গণপ্রজাতন্ত্রী বাংলাদেশ সরকার
শ্রম ও কর্মসংস্থান মন্ত্রণালয়
কলকারখানা ও প্রতিষ্ঠান পরিদর্শন অধিদপ্তর

ক্যাপ পর্যবেক্ষণের তথ্য

কারখানার নাম	মেসার্স এম্বাপোলো ক্যাশনস লিঃ
ঠিকানা	PLOT # I-5/2, ROAD # 7, SEC # 7, MIRPUR, DHAKA
কারখানার কোড	DHK060
কালার কোড

মূল্যায়নের ধরণ: বৈদ্যুতিক মূল্যায়ন	পর্যবেক্ষণের তারিখ: ০২-০৪-২০২৩
১. পর্যবেক্ষণ

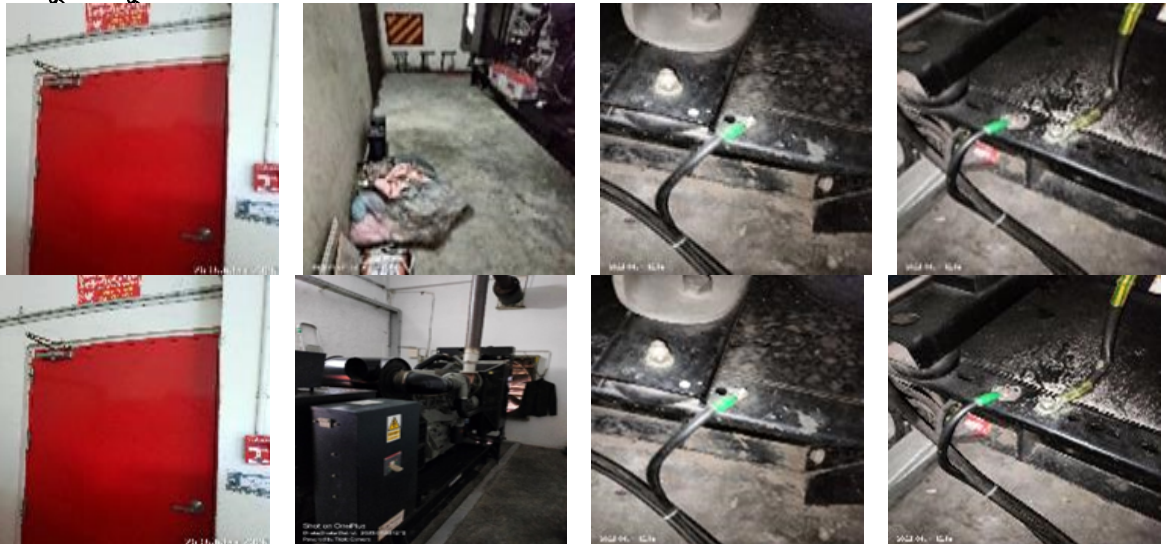
পরিদর্শন পর্যবেক্ষণ	The generator room is not properly segregated from the rest of the occupancy due to presence of non Fire-rated Door □ No detector in generator room □ No firefighting equipment is present in the generator room □ Combustible materials inside generator room □ No over current or earth fault protection provided □ No cover on the cable trench
ক্যাপ আইটেম ক্যাটাগরি

কার্যক্রম	Produce design drawings to demonstrate the incorporation of fire rated enclosure from floor to ceiling and an approved fire rated self-closing swing door for the Generator room. □ Provide firefighting equipment as required by the Guidelines. □ Provide over current and earth fault protection
সুপারিশের তথ্যসূত্র	
কারখানার কার্যক্রম	We have completed all issue except combustible material inside the generator room. We will complete all this issue within the given timeline.
অগ্রাধিকার	৬ সপ্তাহ
চূড়ান্ত সময়সীমা	১৭-০৮-২০১৭
সংশোধিত সময়সীমা	১৫-০৮-২০২২
অগ্রগতির অবস্থা	সংশোধিত
মন্তব্য	29-08-2021 (CVV): 1. Generator is located on ground floor building. 2. They has been provide fire separation. 3. They didn't provide first aid box and artificial respiration. 4. Generator is earthed at two point. 5. Illumination is sufficient in generator room. 6. Dust has not been found in generator room. 7. Factory has submitted detection design to DIFE and waiting for approval. 8. Cover on the cable trench. 14-08-2022: 1. They didn't provide first aid box and artificial respiration. 2. Dust has not been found in generator room. 02-04-2023: 1. Factory has been provided proper fire separation for generator room. 2. Fire detector has been provided for generator room. 3. No combustible materials was found inside generator room. 4. Proper cover on the cable trench was found.

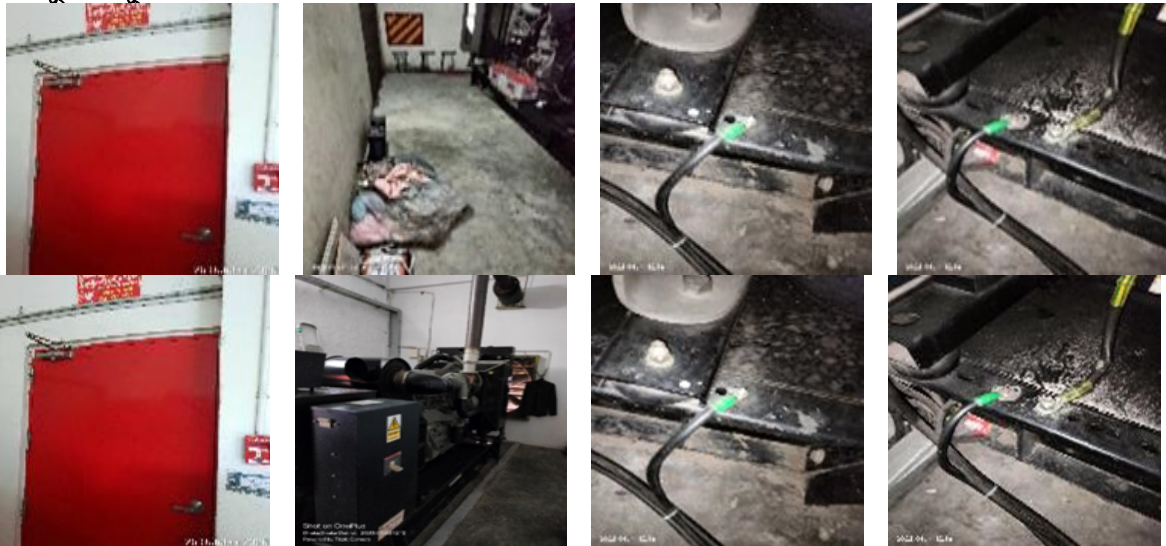
পরিদর্শন পর্যবেক্ষণ	The generator room is not properly segregated from the rest of the occupancy due to presence of non Fire-rated Door □ No detector in generator room □ No firefighting equipment is present in the generator room □ Combustible materials inside generator room □ No over current or earth fault protection provided □ No cover on the cable trench
ক্যাপ আইটেম ক্যাটাগরি

কার্যক্রম	Remove Combustible materials from generator room. □ Provide cover on the cable trench
সুপারিশের তথ্যসূত্র	
কারখানার কার্যক্রম	We have provided cable tray at generator room. We will complete all this issue within the given timeline.
অগ্রাধিকার	প্রযোজ্য নয়
চূড়ান্ত সময়সীমা	১৭-০৮-২০১৭
সংশোধিত সময়সীমা	০১-০১-১৯৭০
অগ্রগতির অবস্থা	সংশোধিত
মন্তব্য	29-08-2021 (CVV): 1. Generator is located on ground floor building. 2. They has been provide fire separation. 3. They didn't provide first aid box and artificial respiration. 4. Generator is earthed at two point. 5. Illumination is sufficient in generator room. 6. Dust has not been found in generator room. 7. Factory has submitted detection design to DIFE and waiting for approval. 8. Cover on the cable trench. 14-08-2022: 1. They didn't provide first aid box and artificial respiration. 2. Dust has not been found in generator room. 02-04-2023: 1. Factory has been provided proper fire separation for generator room. 2. Fire detector has been provided for generator room. 3. No combustible materials was found inside generator room. 4. Proper cover on the cable trench was found.
